Planning

Delegated officer report for planning application

Application no.	144963/NMC/2026
Date registered valid:	16 January 2026
Proposal:	Non-material amendment of Condition 2 (approved plans) for cladding fixing arrangement to Core 1 cladding and replacement of windows to Planning Permission 132801/FO/2022 as amended by 142217/NMC/2025..
Address:	Base Apartments, 12 Arundel Street, Manchester, M15 4JR
Ward(s):	Hulme Ward
Applicant:	Anita Goater Base Management Services Ltd. C/o Stevenson Whyte
Agent (if any):	Easton Bevins
Case officer:	Sam Elliott Tel: 0161 219 2856 Email: sam.elliott@manchester.gov.uk
Recommendation:	Approve
Date of recommendation:	06/02/2026

(Location Plan specifying scope of 144963/NMC/2026 application in relation to previous non-material amendment 142217/NMC/2025)

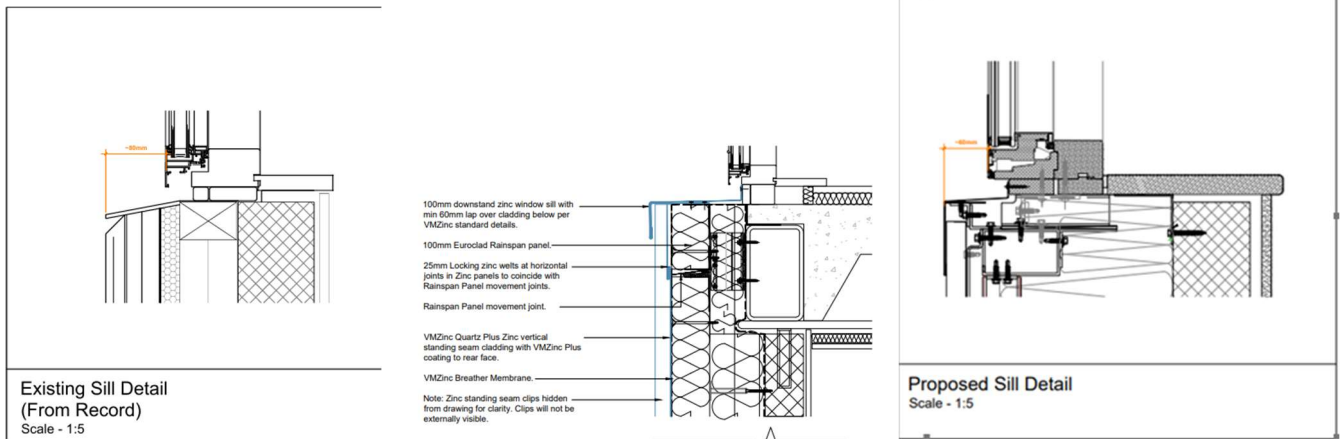
Originally, the building exhibited a sill depth of 80mm. As approved in application 142217/NMC/2025 there is a deeper window reveal of 170mm across the site where cladding is replaced. Where the separate fixing arrangement has been installed to Core 1 due to damaged blockwork this is a depth of 60mm, representing a 20mm loss from the original permission.

While with the fixing arrangement that cladding would come further forward of the elevation and would have a 60mm sill depth, the 20mm loss of sill depth from the 80mm approved as part of original application 132801/FO/2022 is not considered to substantially impact the already relatively shallow window reveal. This is therefore not considered to significantly impact the appearance of the building.
